Gumti Textile Ltd. (Extension)

21 August 2025

1. Building Information

Observation-01: Settlement of floor, crack and tilting of wooden shore pile in Shed 2 & 3.

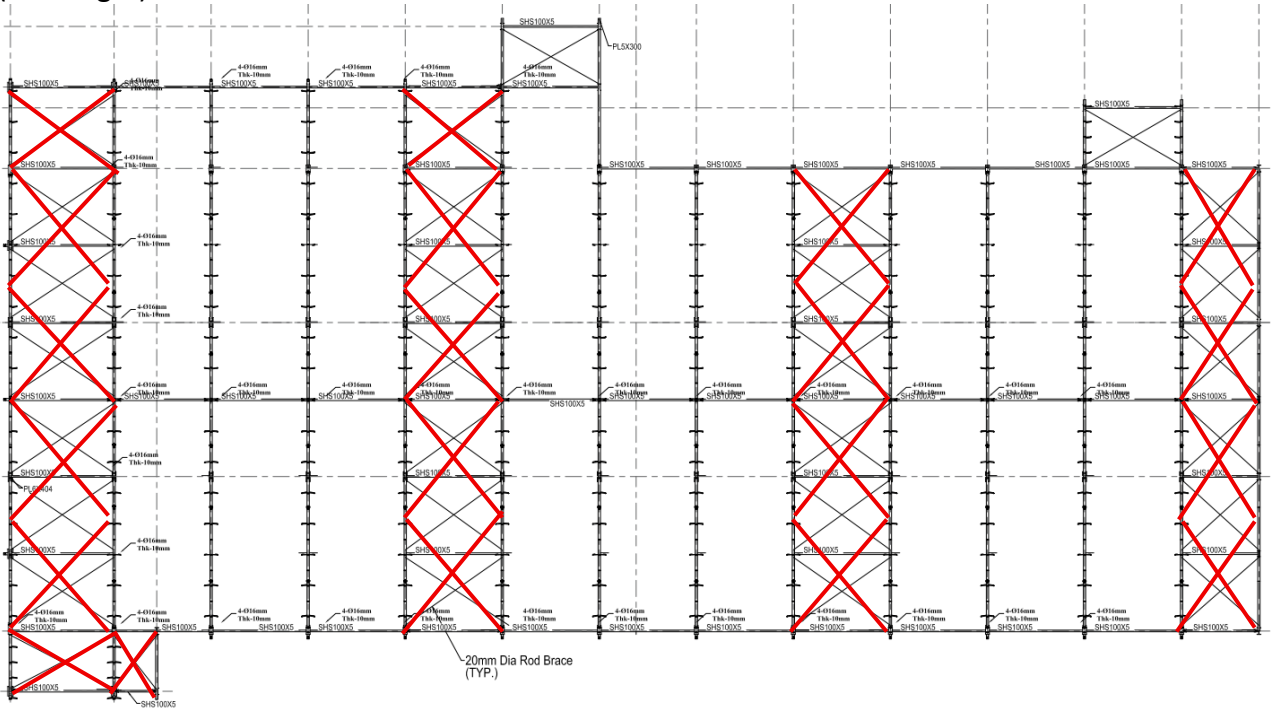
Tilting of wooden shore pile

Settlement of the floor and cracks

Description: Settlement of the floor and settlement cracks were observed on the edges of the sheds 2 & 3 near the water body. Also, the tilting of the wooden shore pile was observed.

1. Building Engineer to check the shore protection and retaining wall capacity to assess the risk of collapse.
2. Appoint a Geotechnical Expert to investigate cracks, settlement, and pile tilting.
3. Implement interim safety measures recommended by the Geotechnical Expert.

Observation-02: Inconsistency between the construction drawing and the onsite condition (Building D)

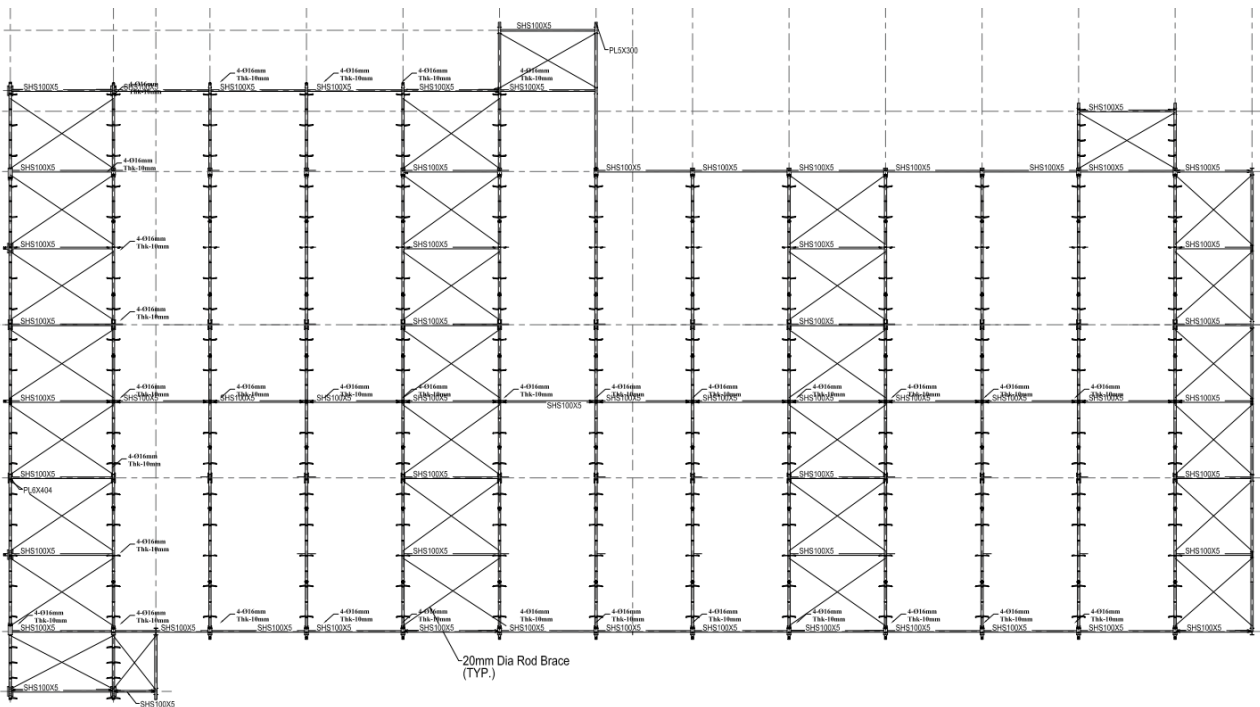
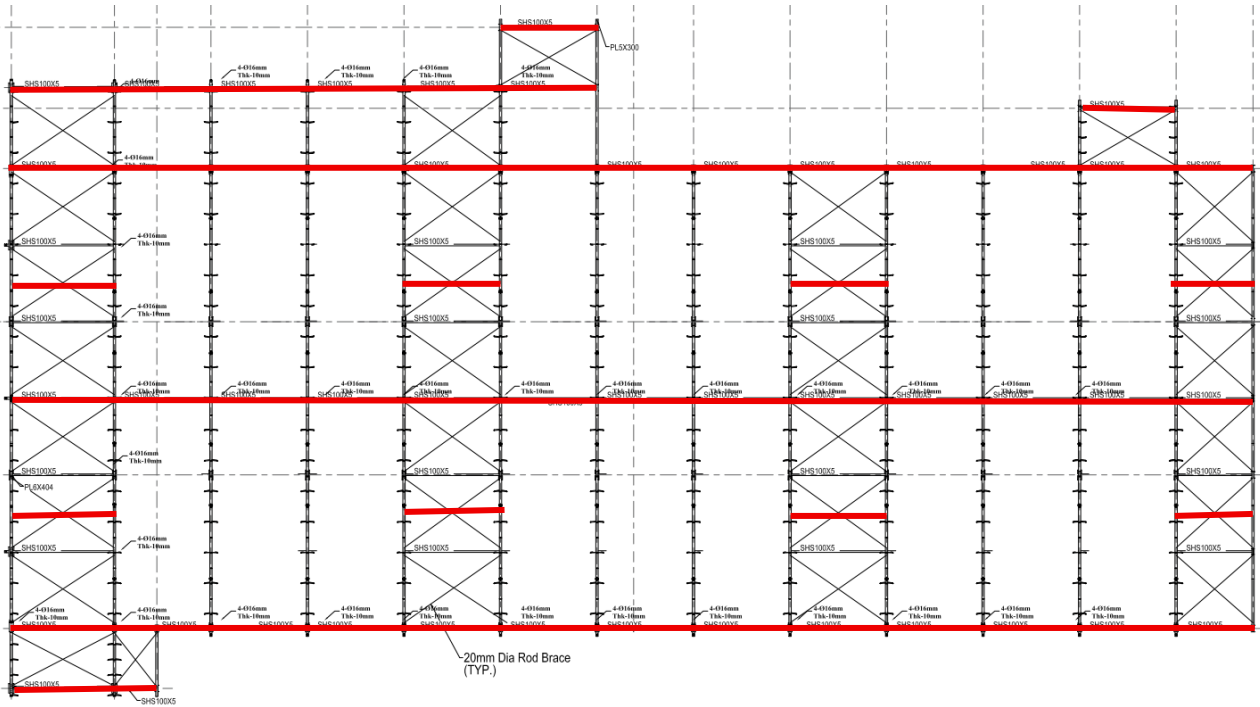
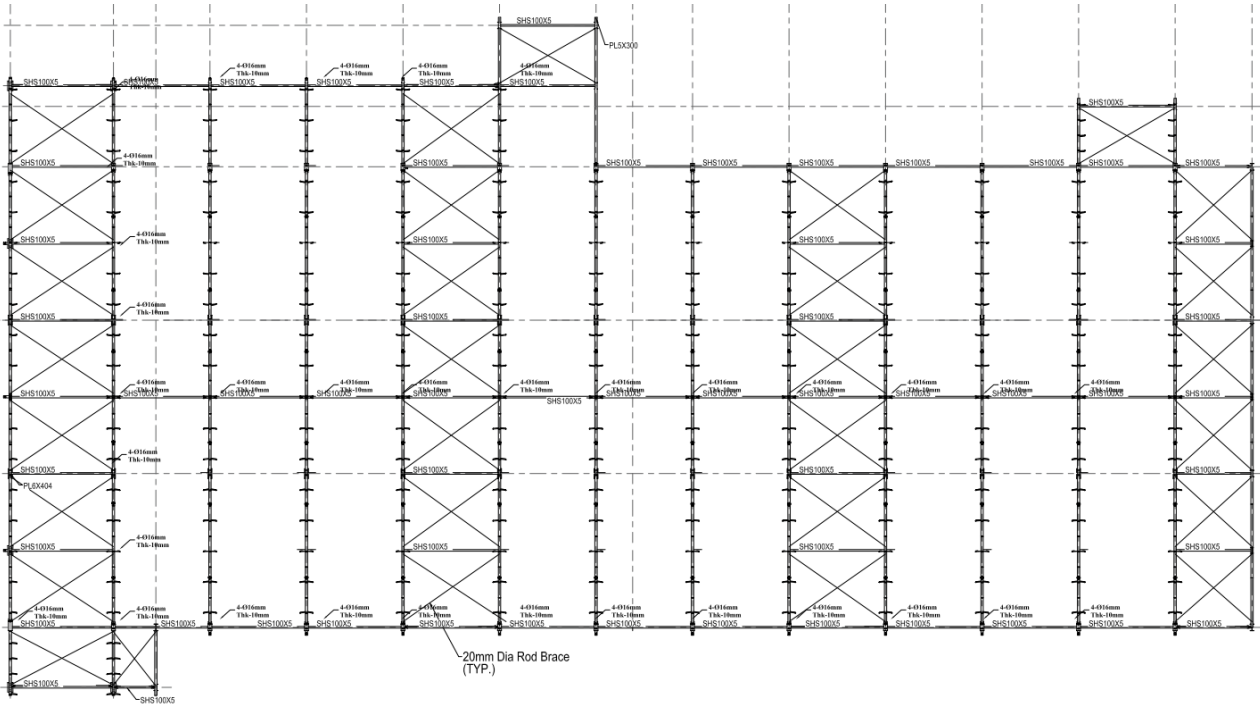
Bracing layout as per site condition (red marked)

Bracing layout as a drawing

Strut layout as per site condition (red marked)

Strut layout as per drawing

Description: Discrepancies were observed between the construction drawings and onsite conditions regarding the roof bracing and compression strut layout. Eccentric connections (highlighted in yellow) were found where concentric connections were specified. The building engineer is required to survey the entire structure and prepare as-built drawings that accurately reflect site conditions.

5.		Carry out the required remedial work where required.	within 6 months
6.	Inconsistency between the construction drawing and the on-site conditions (Building D)	The building engineer is required to survey the entire structure and prepare as-built drawings that accurately reflect the actual site conditions.	within 6 weeks

Observation-05: Faulty erection (Building D)

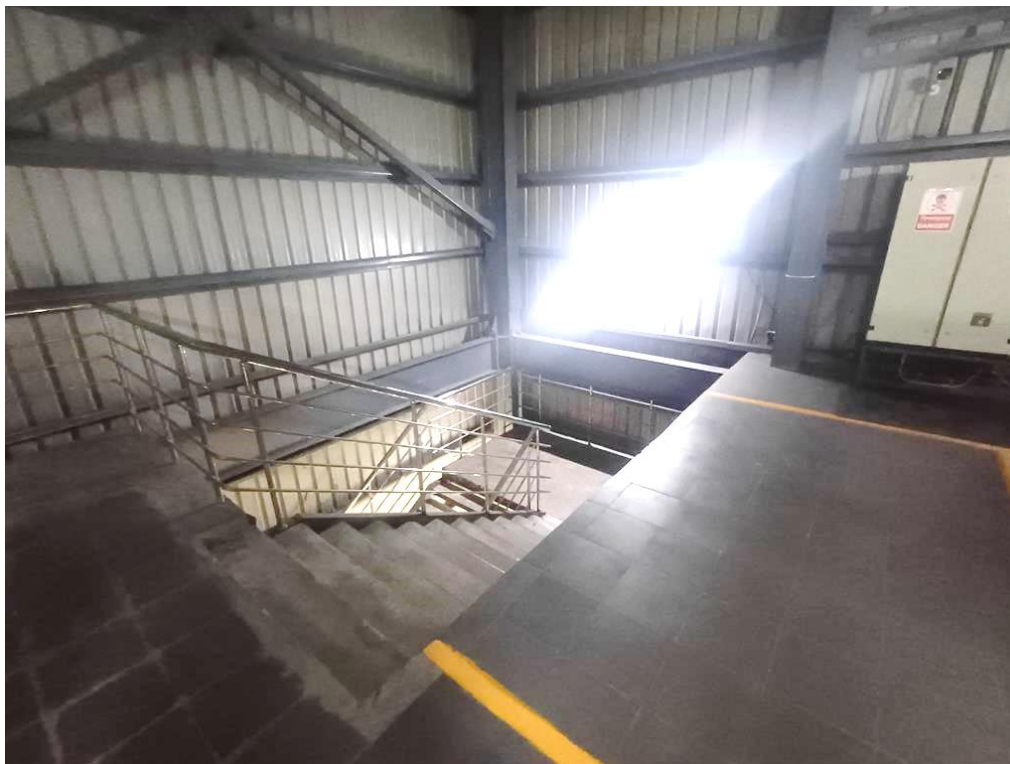
Misaligned vertical bracing

Connection gap

extra hole in the connection

Description: During inspection, faulty erection was observed at several locations. The building engineer is required to investigate, identify & rectify all fabrication faults by suitable methods.

11.	Faulty erection (Building D)	Building engineer is required to investigate, identify & rectify all fabrication faults by suitable methods.	within 6 weeks

Observation-10: Corrosion on steel member (Building D, Shed 2, Shed 3, Toilet Zone, CNG RCU, LPG Storage & Vaporizer)

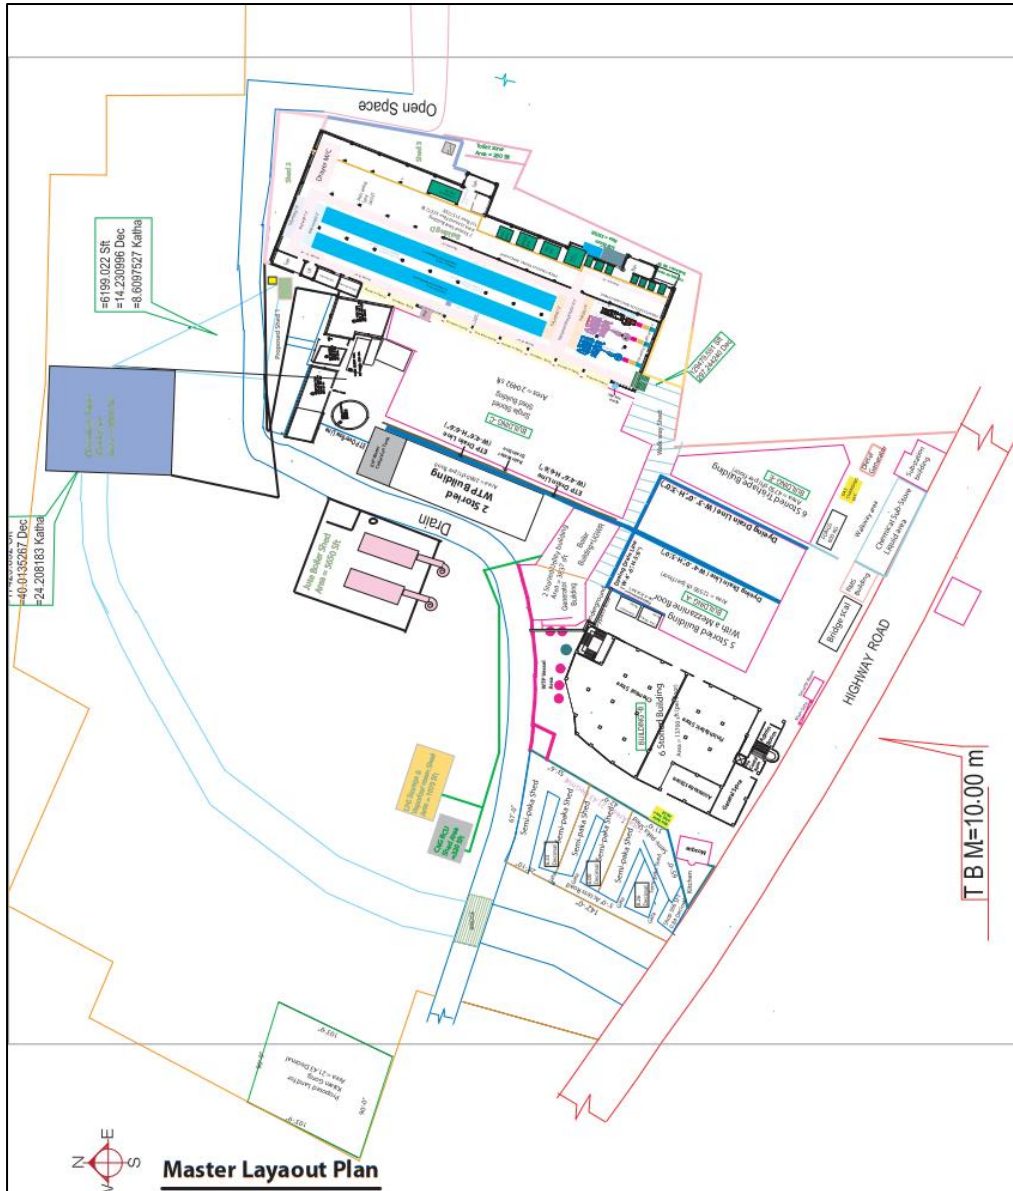
Description: During inspection, corrosion was observed at several locations. The building engineer is required to remove rust and apply anti-corrosive paint on steel members.

12.	Falling hazard (Building D)	The factory is required to provide railing or fall protection on the stairs.	within 6 weeks
13.	Corrosion on the steel member (Building D)	The building engineer is required to remove rust and apply anti-corrosive paint on steel members.	within 6 weeks
